HERBATA DATA CENTRE, NAAS - RESPONSE TO REQUEST FOR FURTHER INFORMATION ("RESPONSE TO RFI") FROM KILDARE COUNTY COUNCIL

ADDENDUM TO CHAPTER 12 TRAFFIC AND TRANSPORTATION

NI2615
01
June 2025

Figure 12.1: Detail of Proposed R409 Improvements (extract of now submitted drawing 2232-DOB-ZZ-ZZ-DR-C-1600)

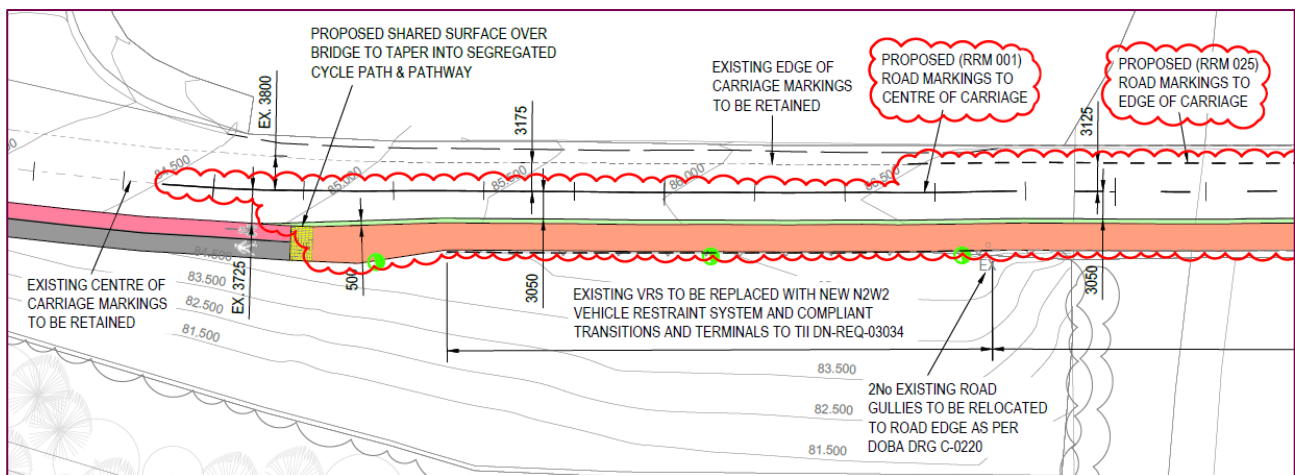
As described in the Addendum to Chapter 4 of the EIAR, following engagement with Kildare County Council Roads Department, amendments are proposed in respect of the provision of a footpath and cycle path along the R409 Caragh Road, where it crosses over the M7 motorway on an overbridge (crossing above the Motorway Maintenance and Renewal Contract [MMaRC] area as described in detail in Section 4.7.1 of the RFI Response Report submitted as part of the response to the Kildare County Council RFI).

The amendments propose a footpath and associated line markings, and replacement of the traffic barriers, which will be undertaken on the R409 (where it crosses over the M7 motorway) and are detailed in Figures 12.1 and 12.2 (extracts from drawing 2232-DOB-ZZ-ZZ-DR-C-1600 PROPOSED R409 ROAD VRU IMPROVEMENTS).

The proposed amendments to the improvements to the R409, as described above and in the addendum to Chapter 4 of the EIAR, have been considered and assessed and will not adversely impact its structural integrity, maintenance, durability, safety or operation of the M7 motorway. Engagement with Kildare County Council National Roads Office and Transport Infrastructure Ireland has informed the proposed amendments and both parties are considered in agreement with the same.

Figure 12.3: Proposed HGV Route from Dublin Port to Site on National Motorway Road Network (extract from updated CTMP, Volume II, Appendix 4.6)

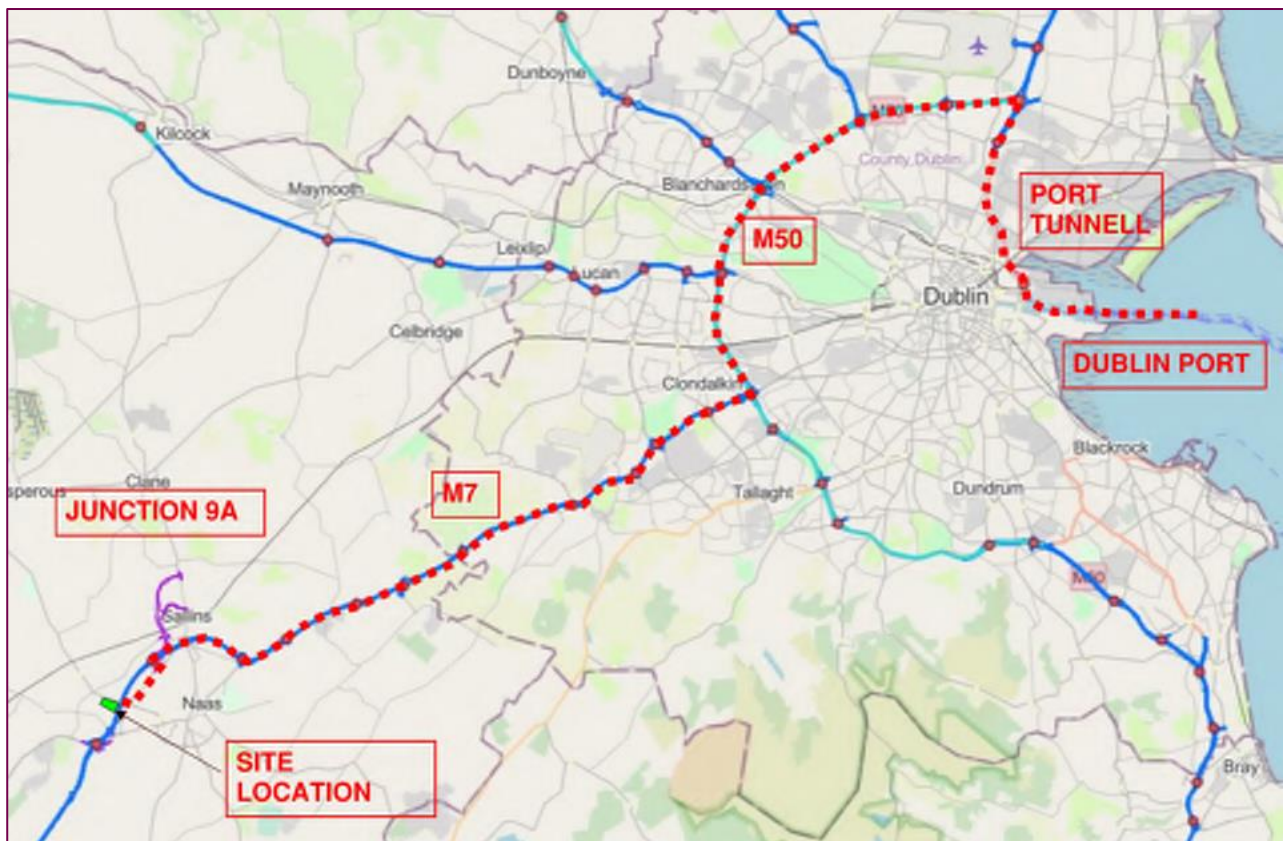
(a) Consultation with all relevant PPP Companies, MMaRC Contractors and the MDO over which the haul route traverses to ascertain any operational requirements such as delivery timetabling, etc. and to ensure that the strategic function of the national road network is maintained.

Dublin Port has been identified as the closest port to the Project and is the port through which imported specialised equipment (turbines and substation components) will be delivered. Figure 12.3 illustrates the proposed route of HGV vehicles transporting imported equipment to the site during the construction phase via the National Motorway Network.

Dublin Port Tunnel's height is designed for safe passage of HGV's height of 4.65m with a width of 2.9m and a length of 25m. Construction vehicles accessing the site from the north or south directions on the M7 can use either Junction 9a or Junction 10 to access the site.
